7 CFR Part 1755

RUS Standard for Service Installations at Customer Access Locations

ACTION: Final rule.

FIGURE 3

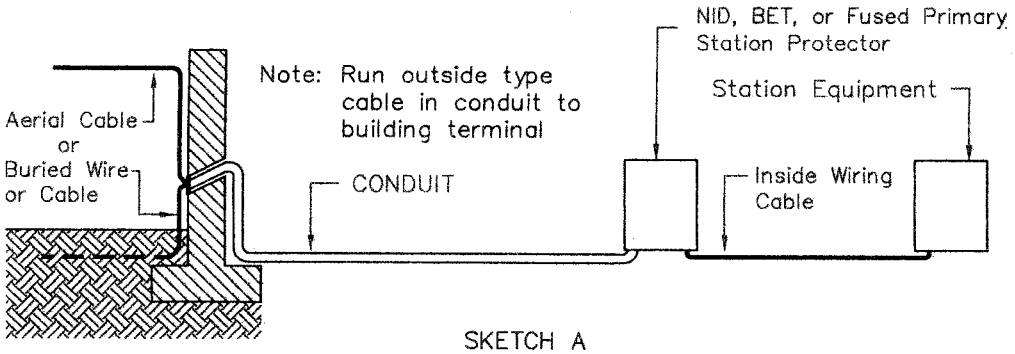
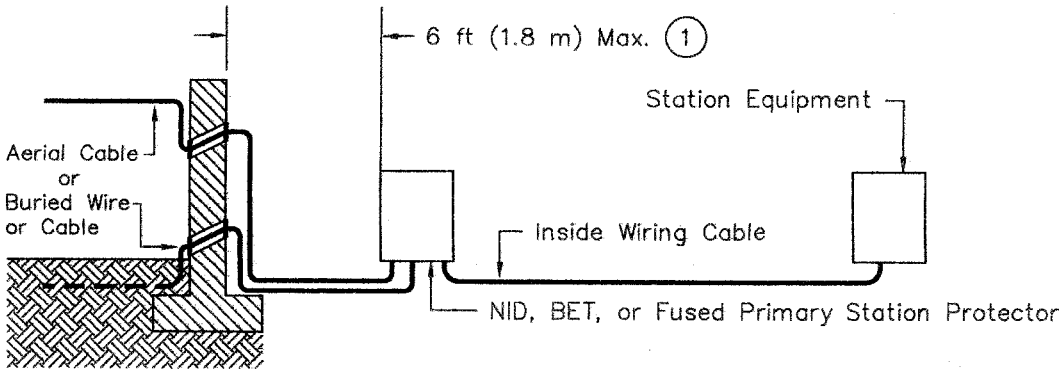
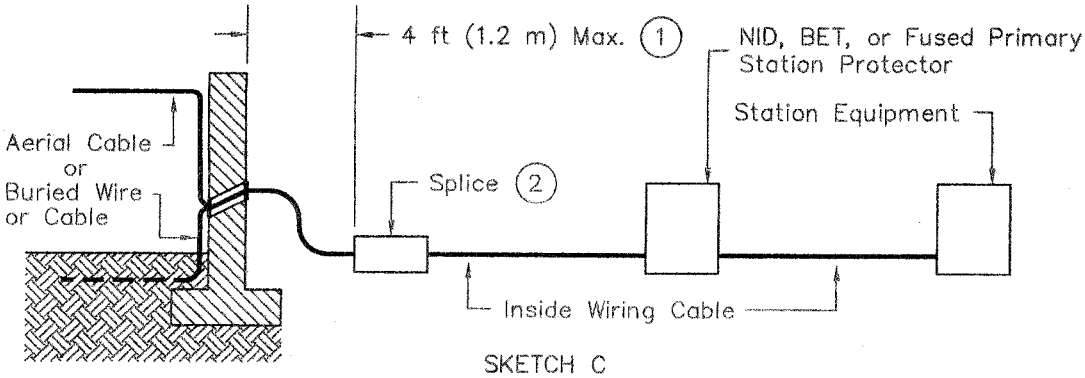
2. Figures 3 and 8 have been revised to reference the 1999 issue of the *NEC*® instead of the 1996 issue of the *NEC*®, which is no longer in effect.

FIGURE 9

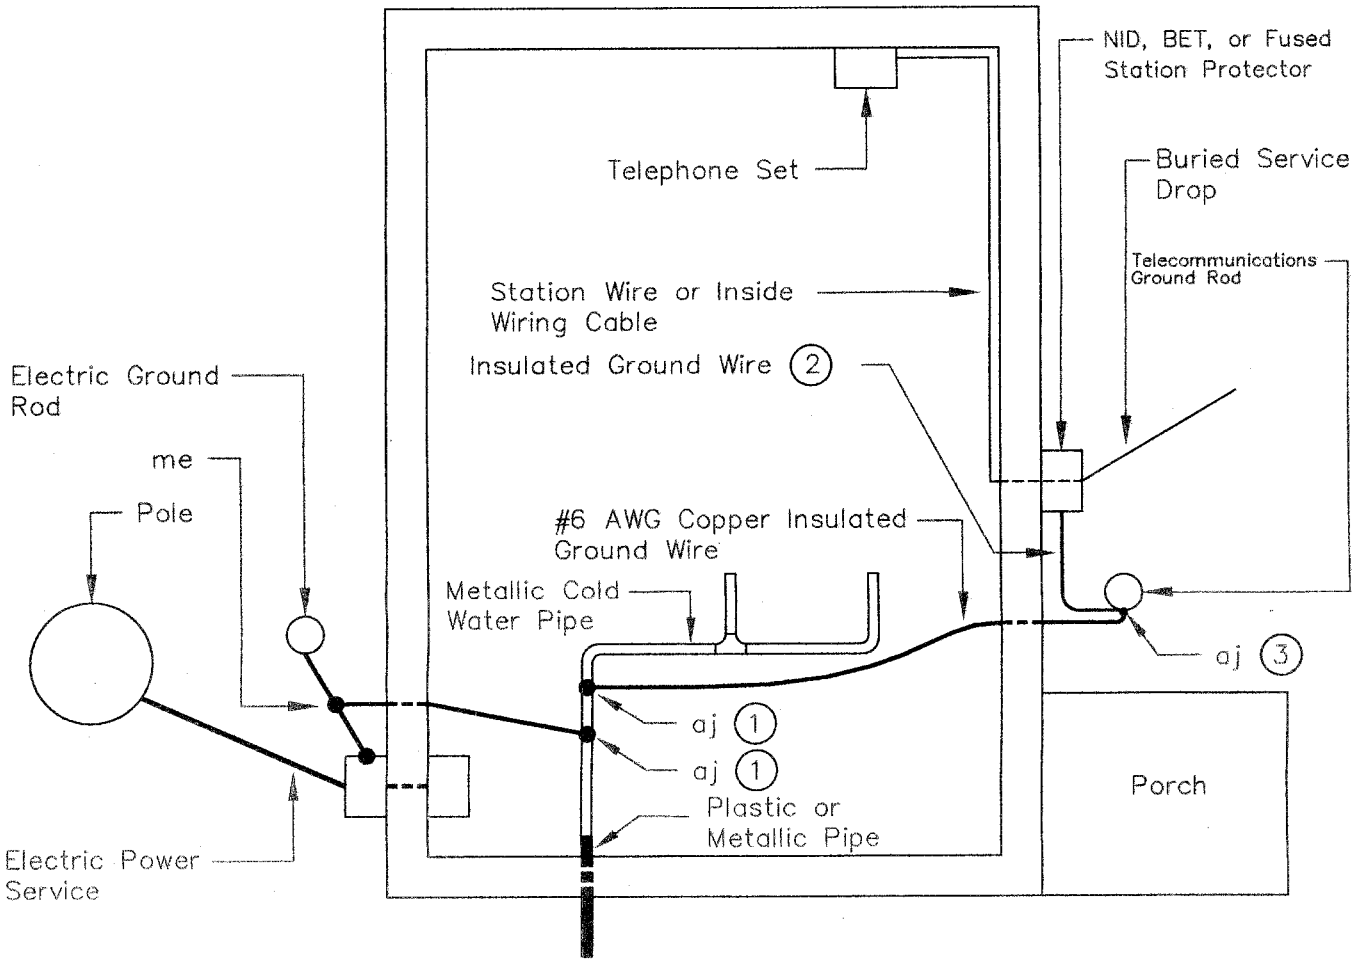
3. Figures 9, 17, and 18 have been revised to indicate generic telecommunications service wire installations at customer access locations instead of specific telecommunications service wire installations at customer access locations because it is impossible for RUS to predict the number of telecommunications service circuits requested by customers. This was accomplished by replacing the references to the ''#12 AWG copper insulated ground wires'' which specify only two pair telecommunications services with generic references to ''copper insulated ground wires'' and ''associated notes'' indicating that § 1755.508(v), Table 5, should be used to determine the correct ground wire conductor size suitable for the installations based on the number of telecommunications circuits installed at customer access locations.

BM50

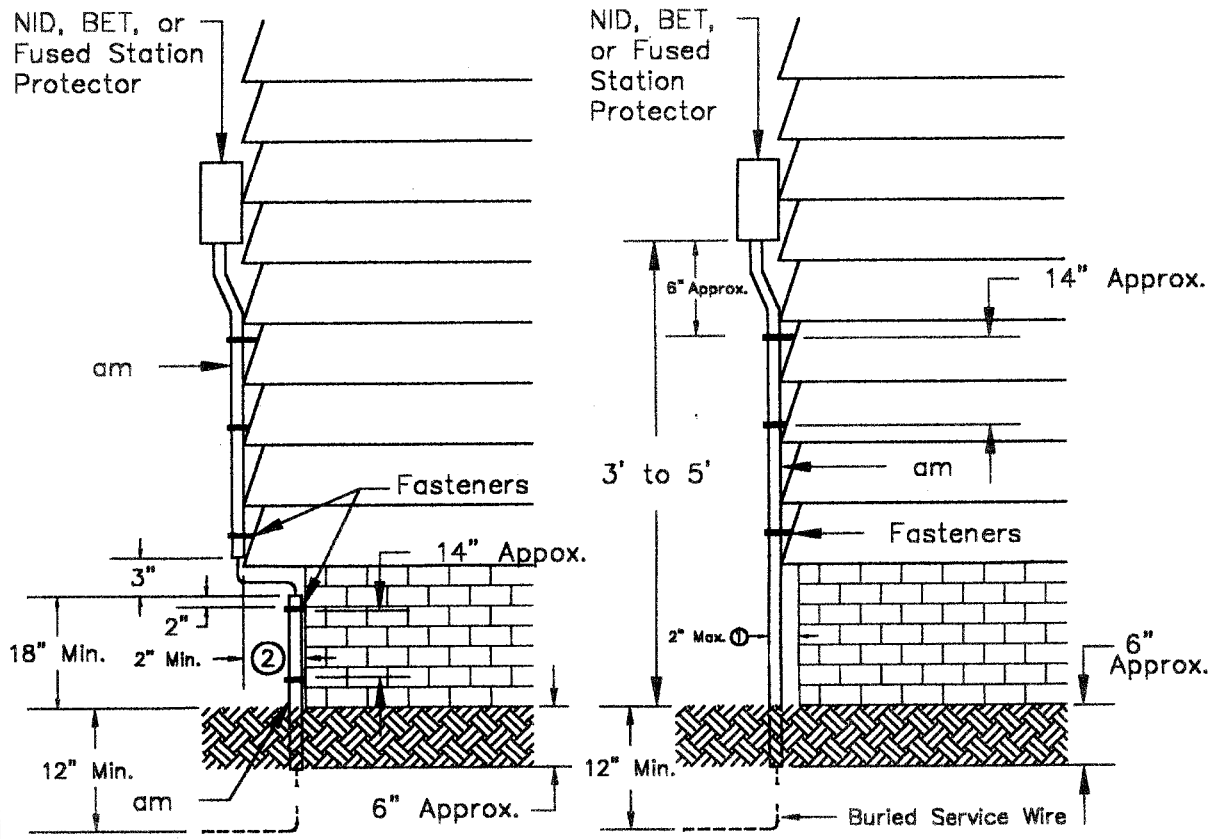
7. The ''BM50 Assembly Unit Drawing'' is being inserted to replace Construction Drawing 912 in § 1755.510. The reason for this change is attributed to current installation practices. Aerial service wires (from buried cables) are installed in accordance with information provided in the BM50 Assembly Unit Drawing not the 912 Construction Drawing. The major difference between the BM50 Assembly Unit Drawing and the 912 Construction Drawing is that the BM50 drawing eliminates the aerial service installation information from the drawing and indicates that the buried plant housing is paid under the buried plant housing assembly unit (BD).

BM83

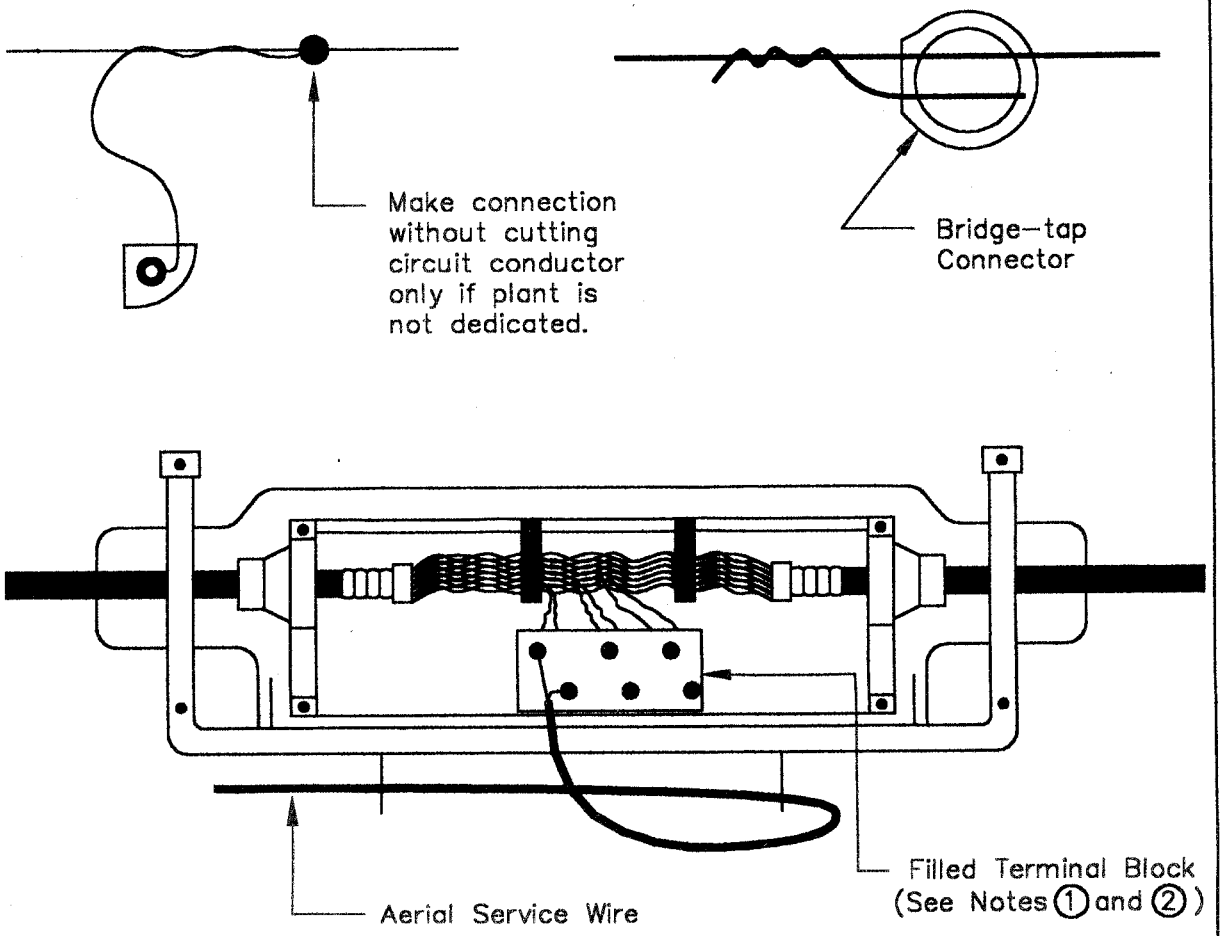
The same respondent recommended that Note 2 of the BM83 Assembly Unit Drawing in § 1755.510 be modified to allow the optional installation of a flexible service guard when an obstruction of greater than 2 in. (51 mm) is encountered instead of requiring two service guards.

Response: After much discussion and consideration, RUS agrees with the comment and is modifying Note 2 of the BM83 Assembly Unit Drawing in § 1755.510 to allow the optional installation of a flexible conduit when obstructions of greater than 2 in. (51 mm) are encountered. The revised Note 2 of the BM83 Assembly Unit Drawing will read as follows: ''Where an obstruction of greater than 2 in. is encountered, the buried service guard (item am) shall be divided as shown (from the NID, BET, or fused protector to the obstruction, and from 3 in. below the obstruction to 6 in. below the ground). In lieu of divided service guards (item am), a continuous flexible conduit may be used from the NID, BET, or fused protector to 6 in. below the ground.''

RURAL TELECOMMUNICATIONS CONSTRUCTION PRACTICES AERIAL PLASTIC CABLE DETAILS OF WIRE CONNECTIONS TO FILLED TERMINAL BLOCKS	
	Scale: NTS	March 2001
		312–1

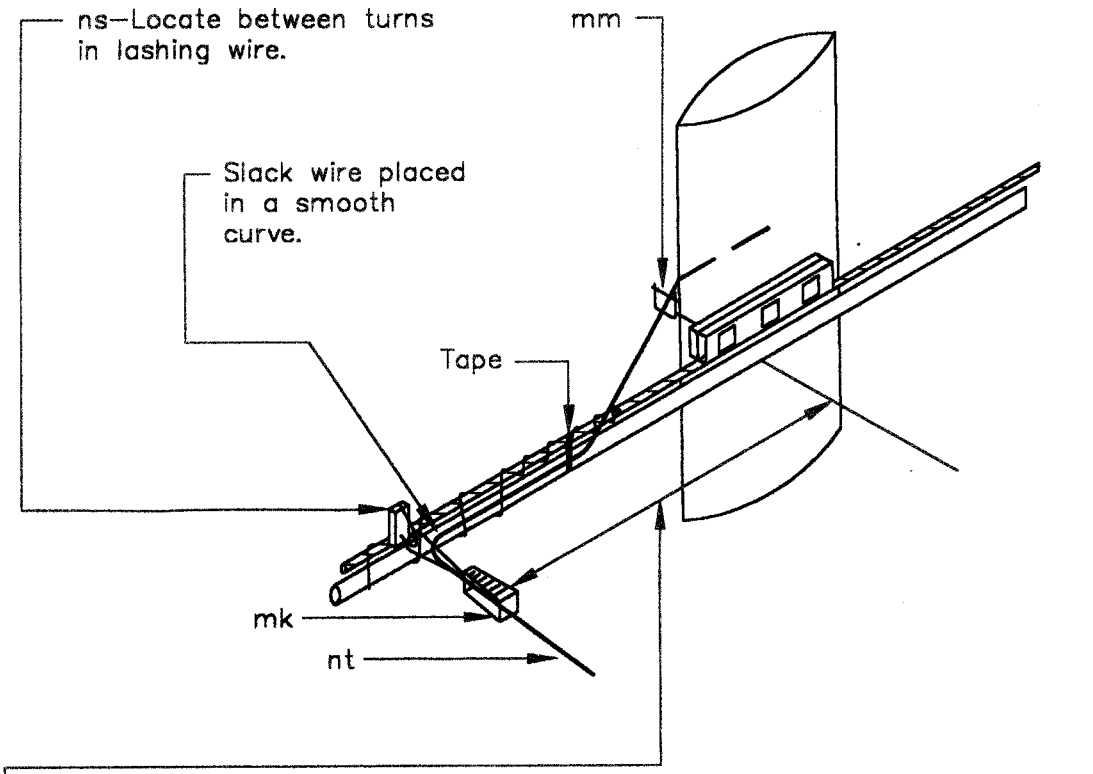
The final comment from the same respondent questioned the editorial and technical correctness of Construction Drawings 312–1, 501–1, 501–2, 702, 958, and 962 in § 1755.510.

4. Construction Drawing 312–1 in § 1755.510 is being changed by adding the respondent's recommended language of ''only if plant is not dedicated'' to the proposed language concerning one of the methods of terminating the lead-out wires of terminal blocks to distribution cable conductors. This new language will read as follows: ''Make connection without cutting circuit conductor only if plant is not dedicated.''

501–1

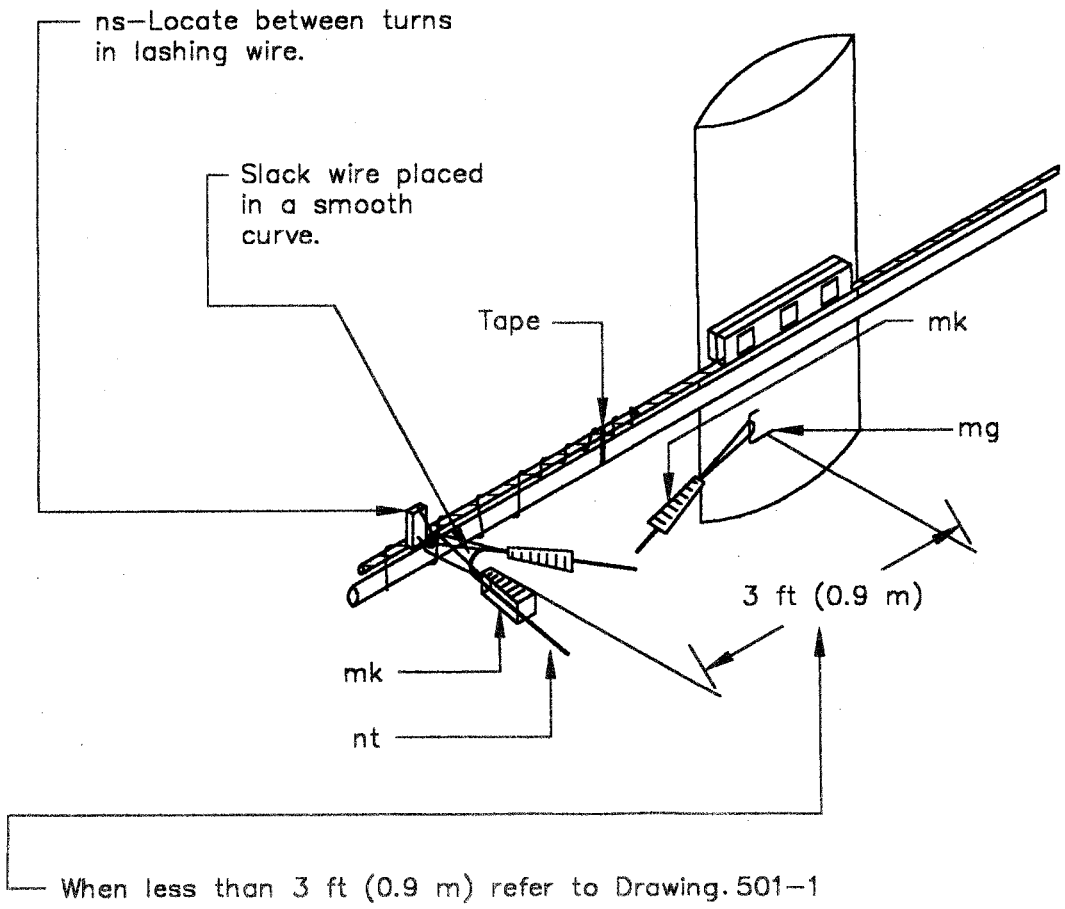
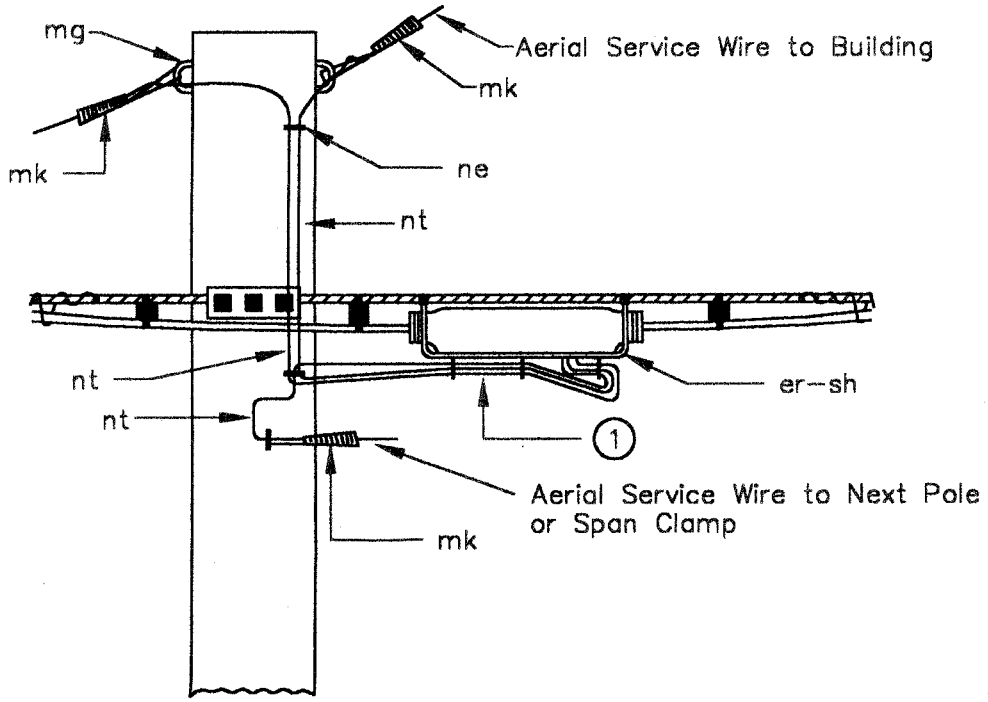
questioned the reason for the ''tape'' component in each of the construction drawings. The ''tape'' component detailed in Construction Drawings 501–1 and 501–2 is required for housekeeping purposes to keep the service wire trained neatly along the distribution cable. Therefore, RUS will not modify Construction Drawings 501–1 and 501–2.

Scale: NTS		March 2001
		958

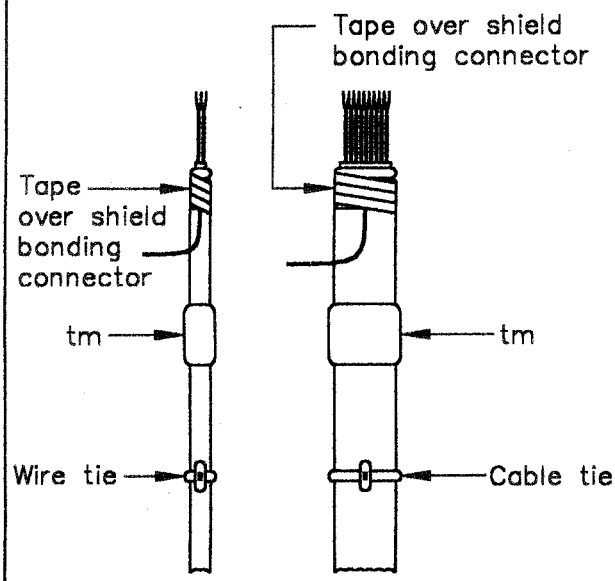
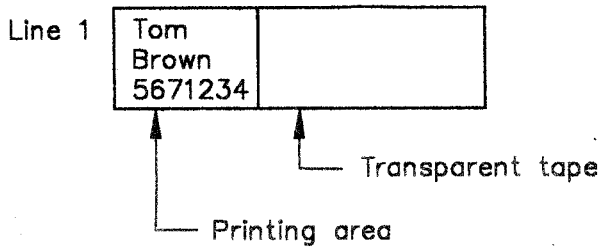
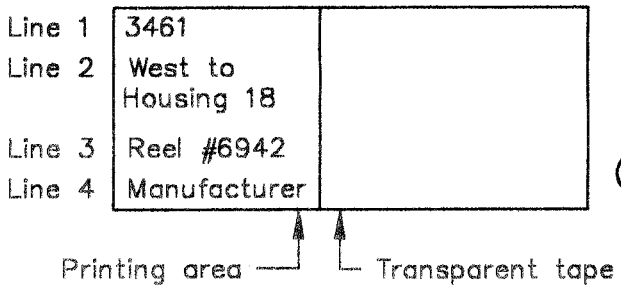
8. Note #4 of Construction Drawing 958 was modified to allow the use of alternative marking materials as requested by the respondent.

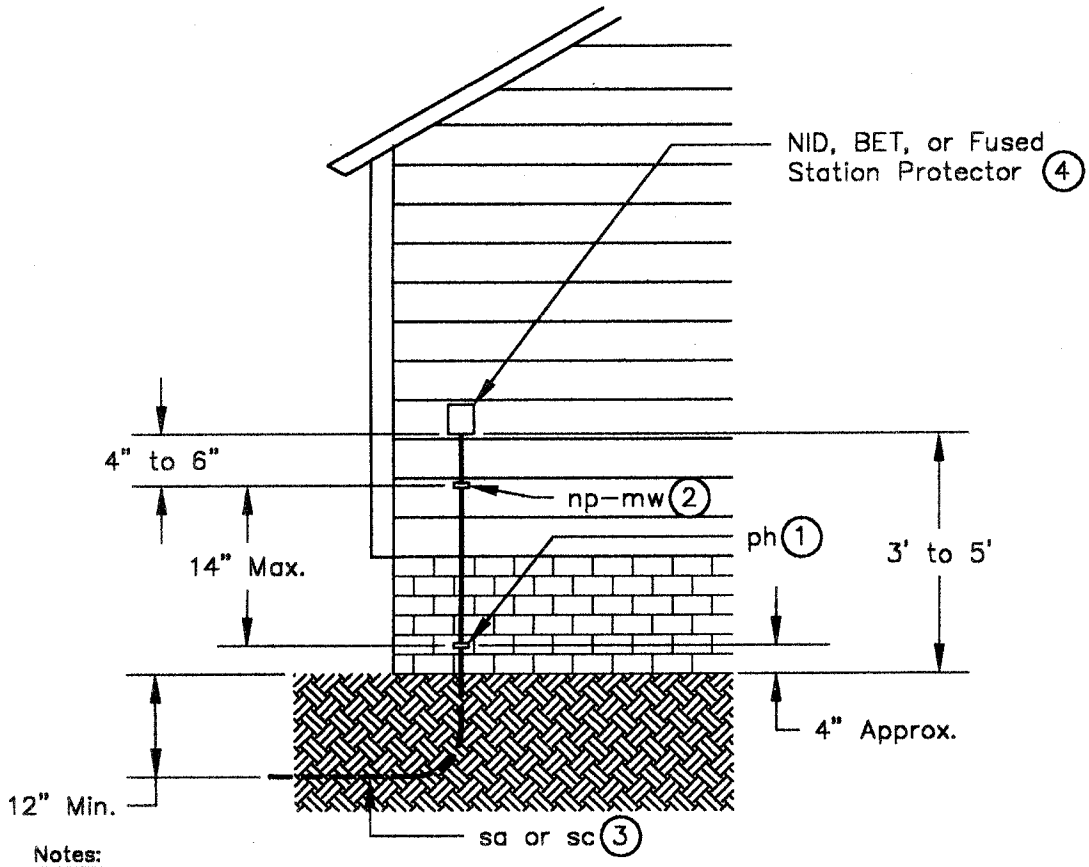
9. The respondent questioned the wisdom of placing the ground wire and service wire under the same attachment device when parallel runs are encountered as indicated in Note #2 of Construction Drawing 962 in § 1755.510. After much discussion and consideration concerning this procedure, RUS is not modifying the proposed Note #2 language of Construction Drawing 962 in § 1755.510 because the allowance of this installation procedure over the past 15 years has not resulted in any service problems at customer access locations.
